**ADDENDUM
NO. 01**

Edwardsburg Public Schools – Middle School and High School Mechanical Upgrades

ADDENDUM NO. 2

PROJECT: **Edwardsburg Middle School – Mechanical Upgrades**
69410 Section St.
Edwardsburg, MI 49112

SHEET TITLE
OVERALL FIRST FLOOR DEMOLITION
PLAN
AD 101
21-201.041

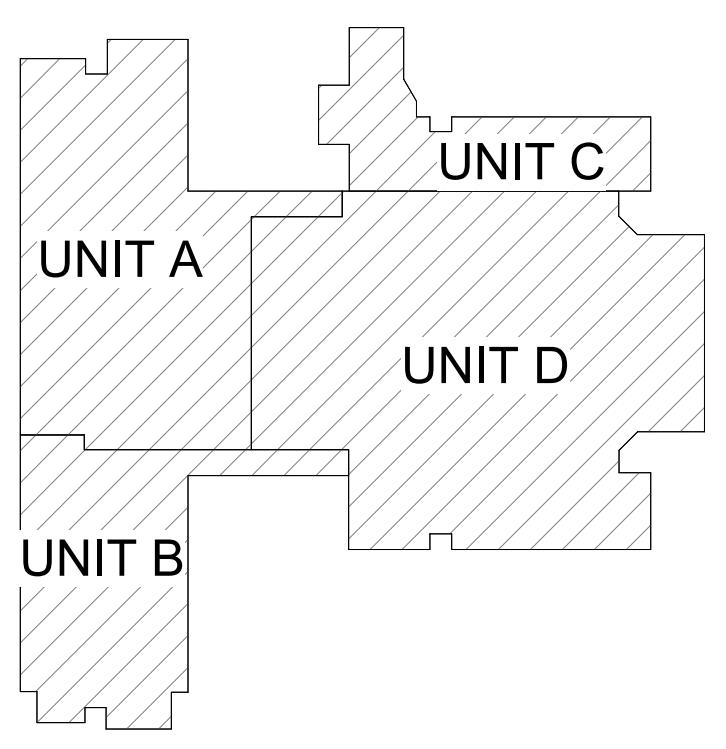
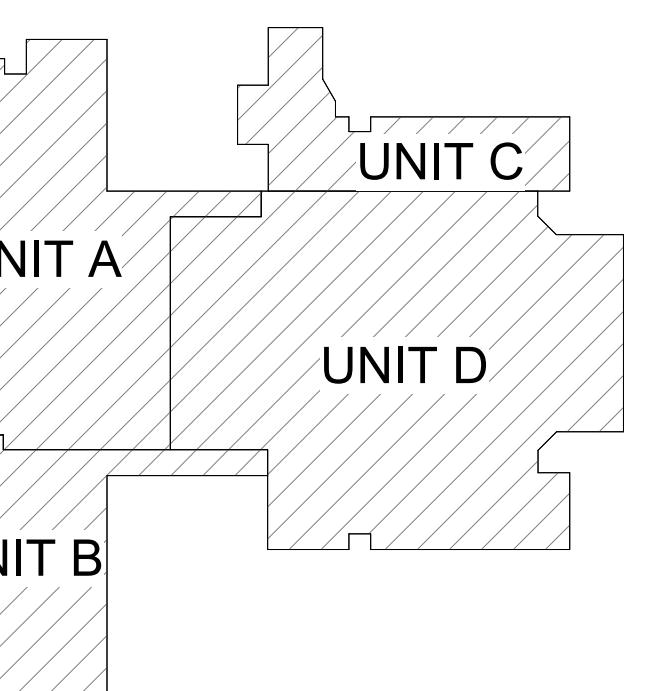
AD 101, A 101, and A 321 - In boiler room, C111, showing door demolition and replacement and new hardware for an existing door. Added some frame details, elevations and door panel elevations.

SHEET TITLE: OVERALL FIRST FLOOR REFLECTED CEILING PLAN
KEY PLAN
SCALE: NO SCALE

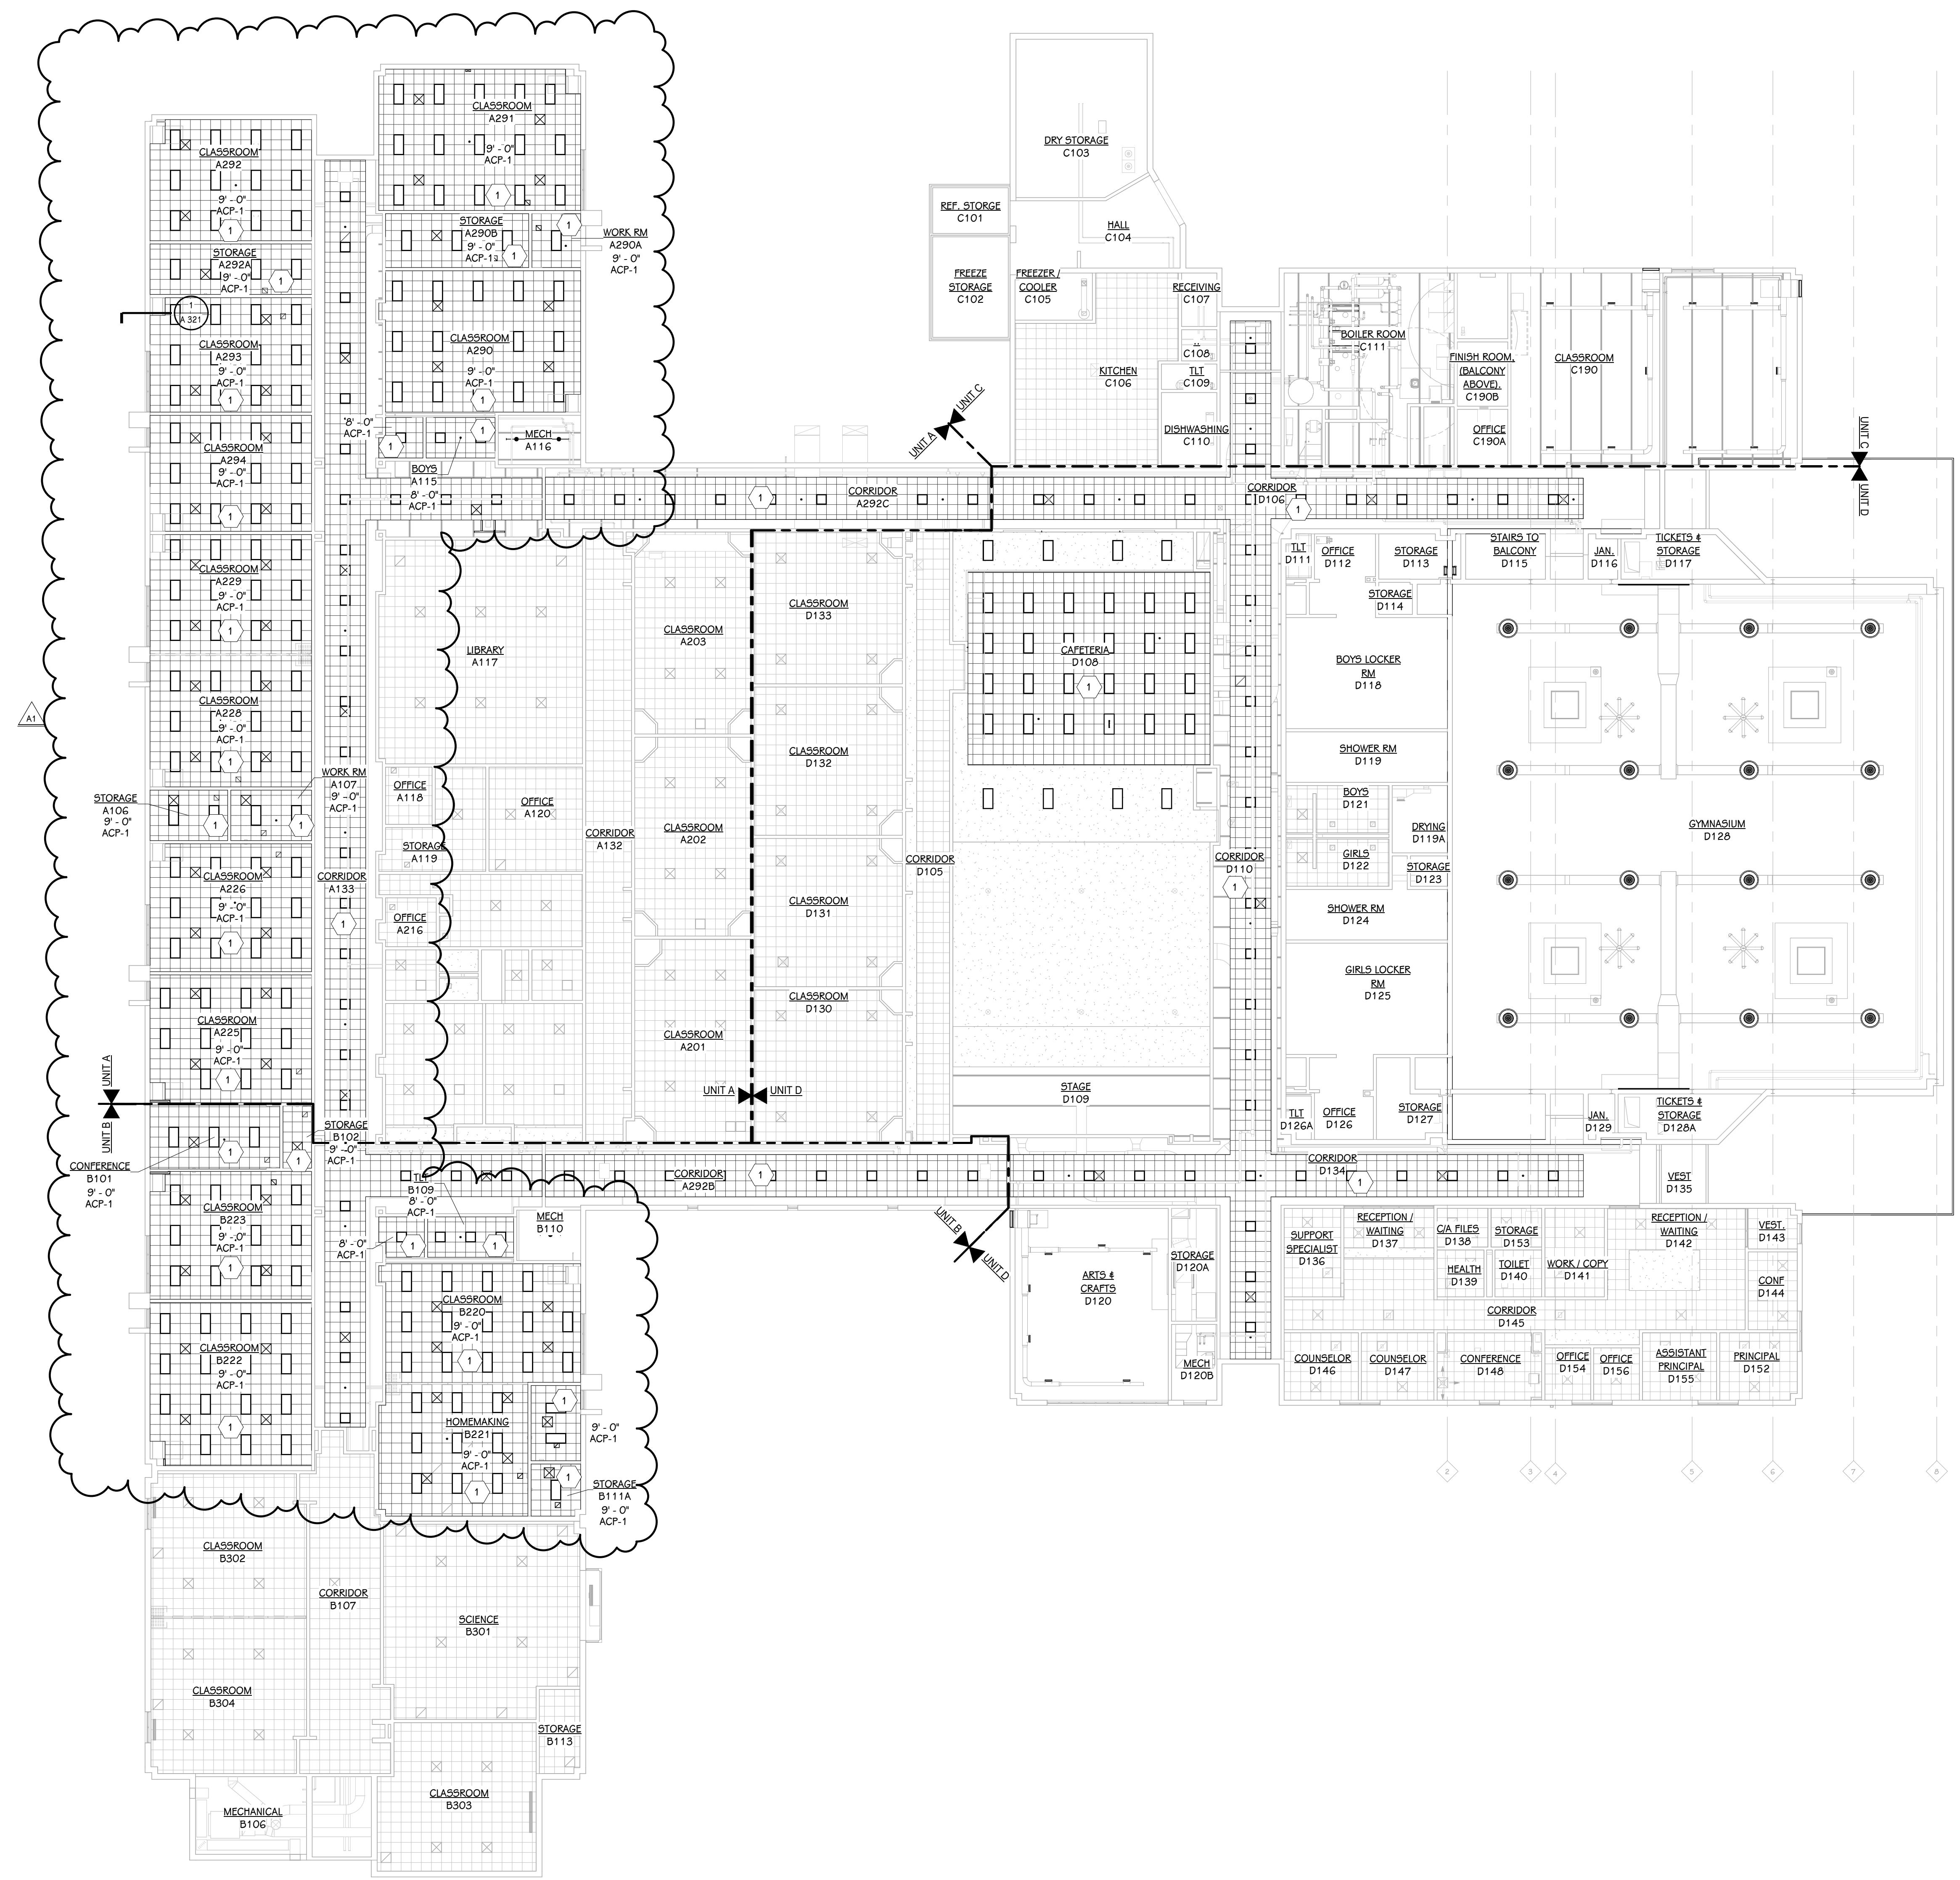
A 201 – Updated keynotes for ceiling to reflect the work that is to be provided as base bid rather than an alternate. Revised ceilings to rooms A115, A106, A107, A290A, B101, B102, and B109.

OVERALL FIRST FLOOR SHEET METAL PLAN
1/16" = 1'-0"

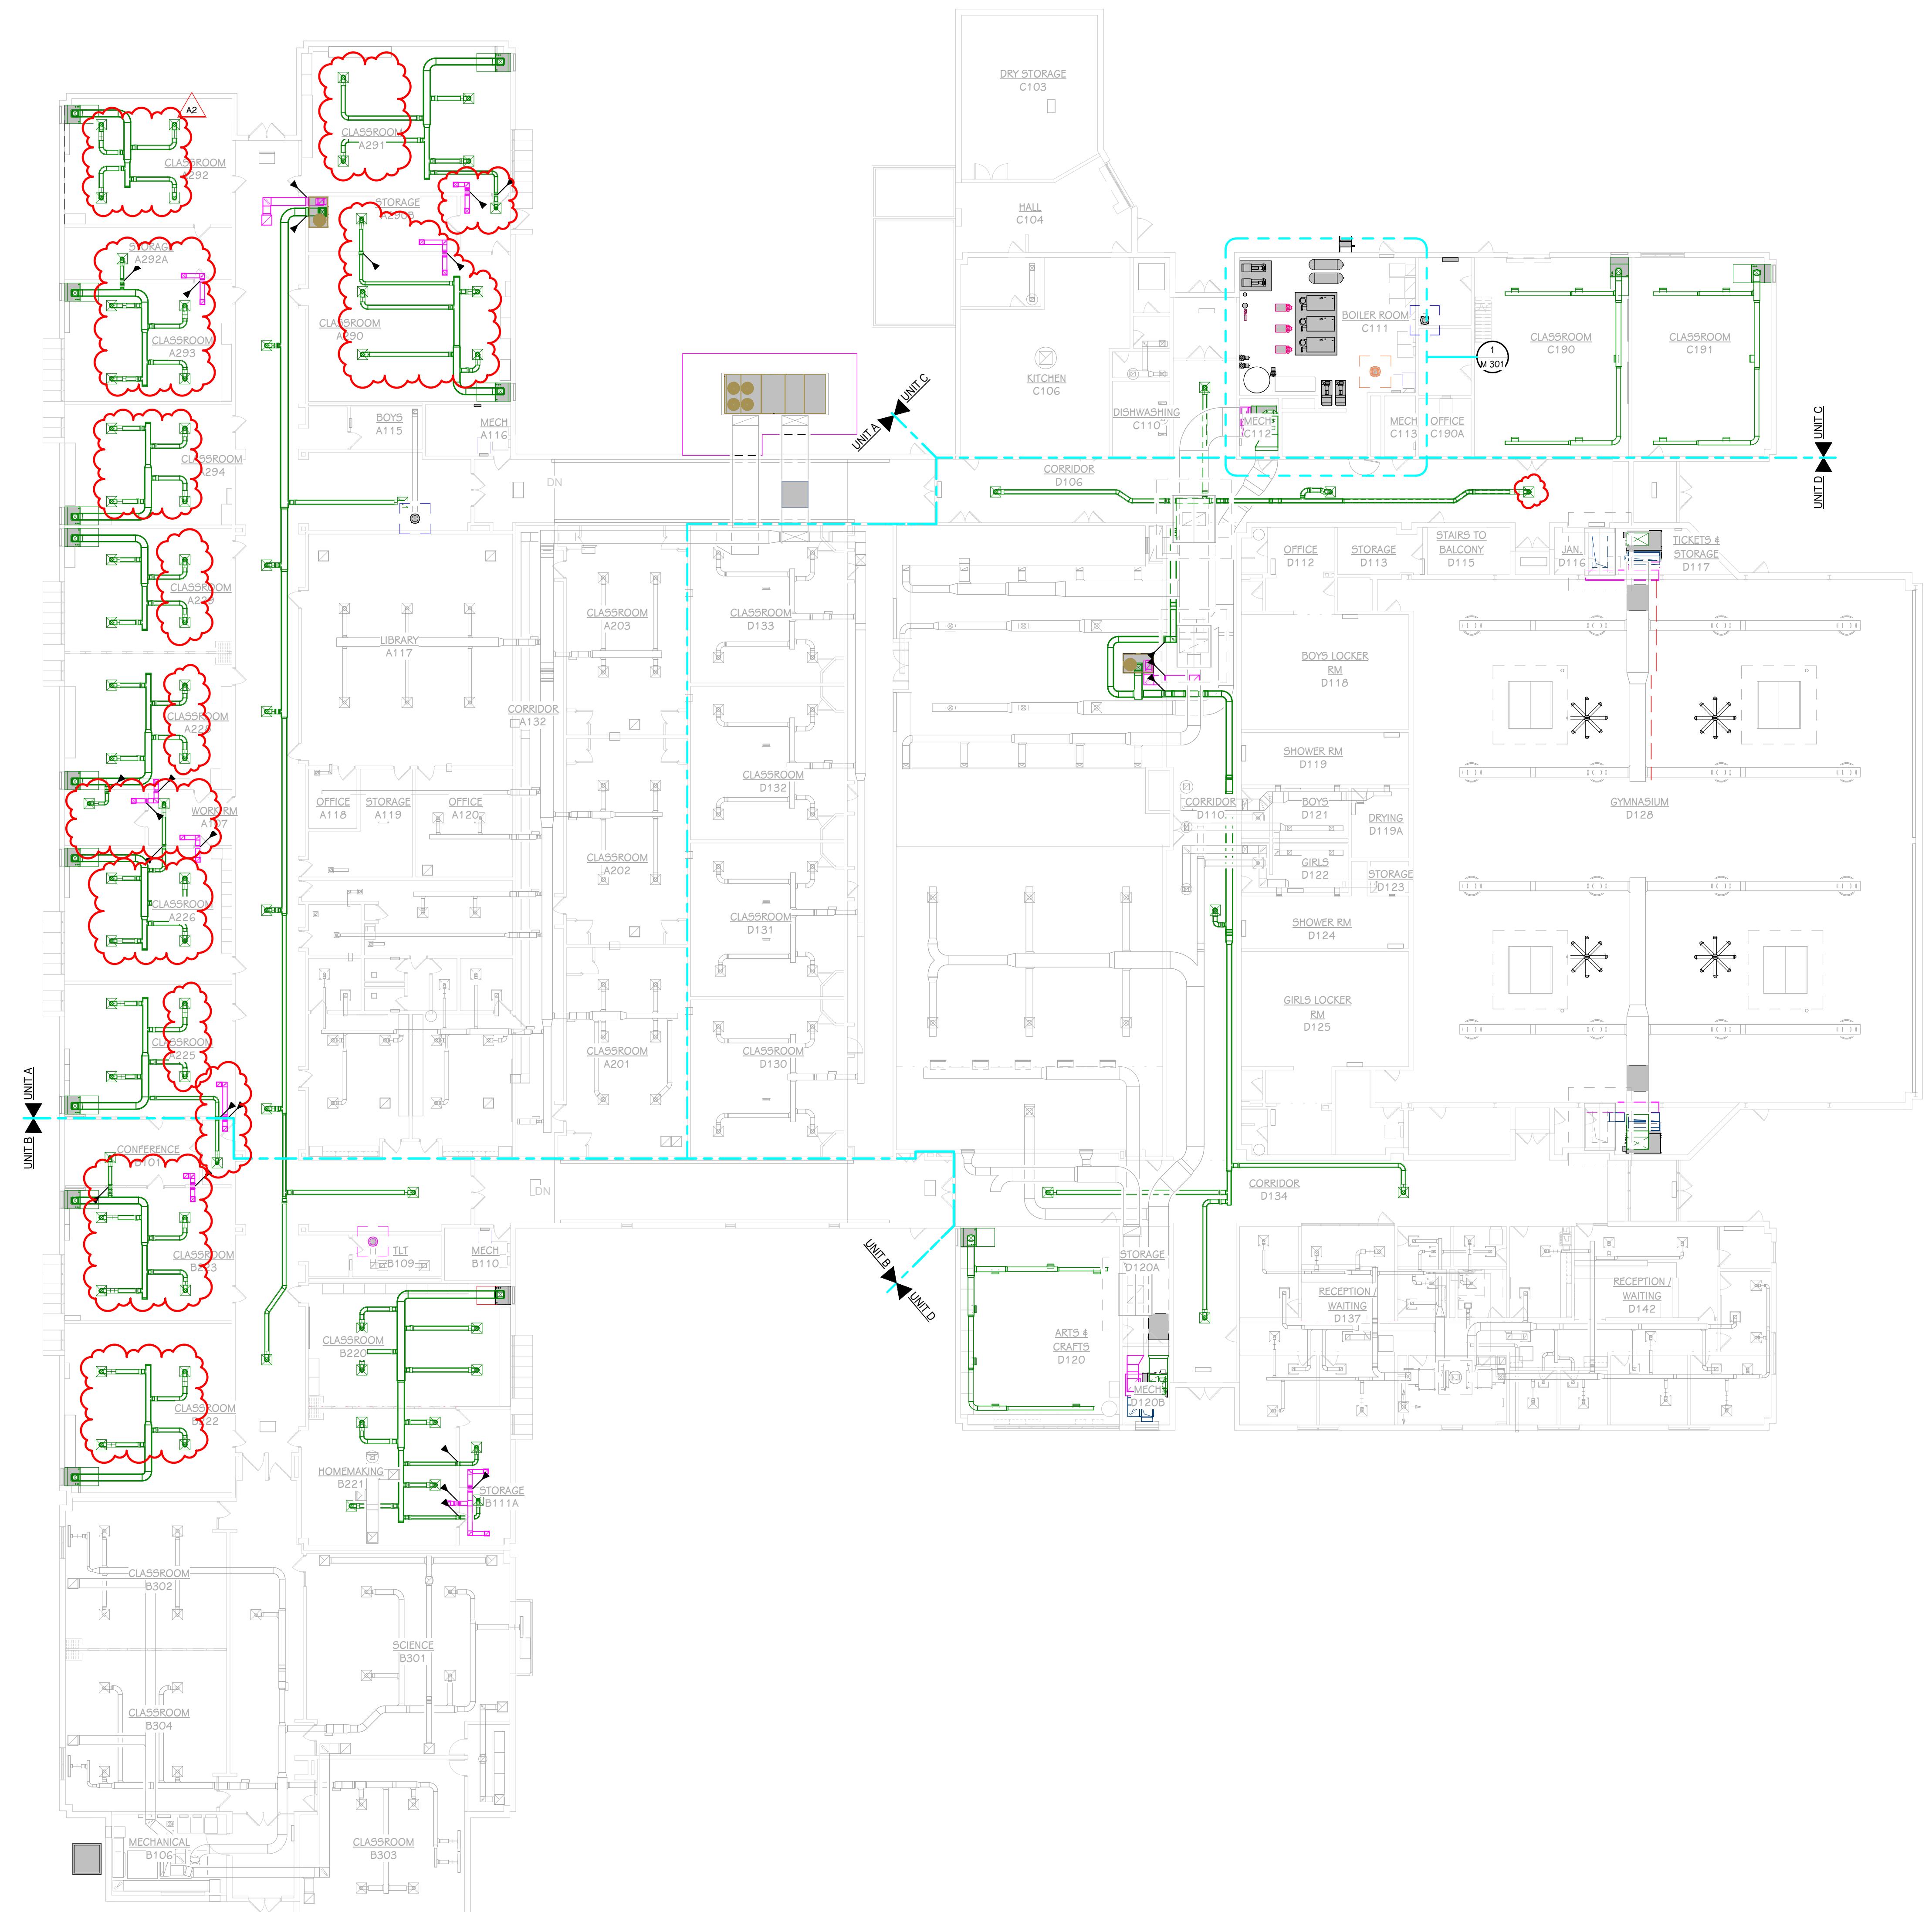
M 101, M 101A, M 101B, and M 101D – Updated diffusers & grille location based revised ceiling grids.
